Subject: Submittal of Updated NAC-MPC FSAR, Revision 5
 Docket No. 72-1025

NAC-MPC FSAR, Revision 5
Summary of 10 CFR 72.48 Changes Included in Revision 5

Figure 13.2-1 NAC International Organization Chart

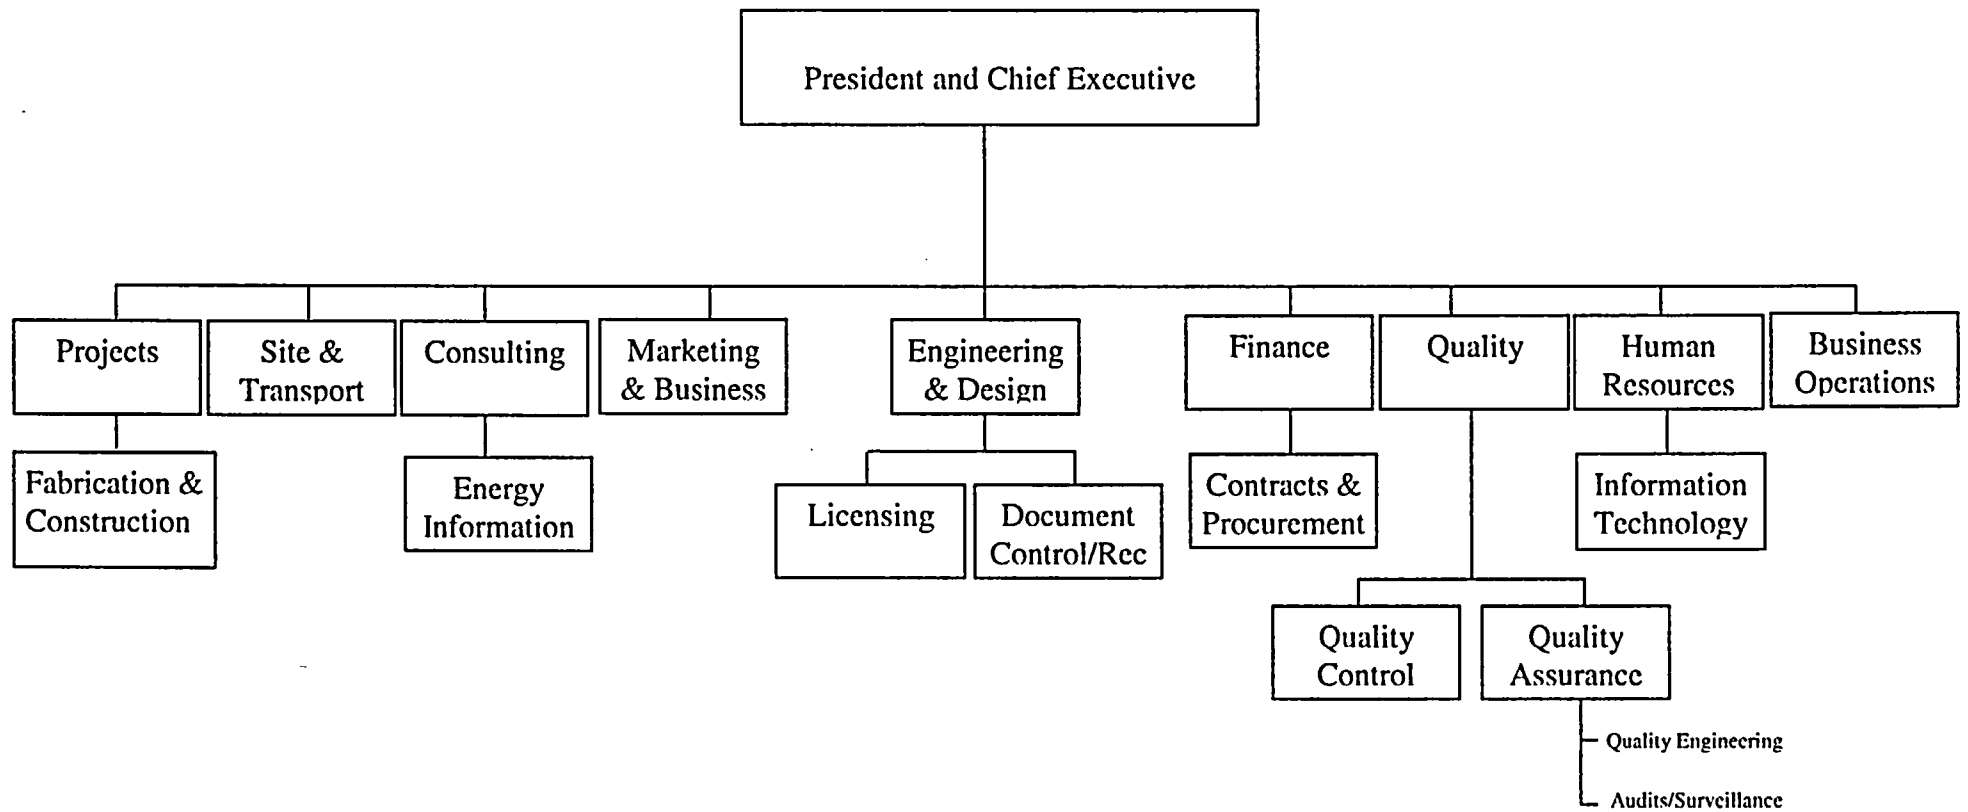
Page 12C3-36	Amendment MPC-03A	C 3.1.7, Surveillance Requirements, 1 st paragraph – changed “Nitrogen” to “nitrogen” & “longer flow allowed” to “longer flow is allowed”; 3 rd paragraph – changed “flow” to “flows”
Page 12C3-37	Amendment MPC-03A	C 3.1.8 -- deleted
Page 12C3-39	Amendment MPC-03A	C 3.2.1, LCO, last paragraph – added last sentence
Page 12C3-40	Amendment MPC-03A	C 3.2.1, Actions, A.1, 2 nd sentence – changed “7 days” to “25 days (600 hrs)” SR 3.2.1.2, last sentence – revised throughout
Chapter 13		
Page 13.2-9, Figure 13.2-1	72.48/DCR(L) MPC- FSAR-4G	Inserted updated organizational chart
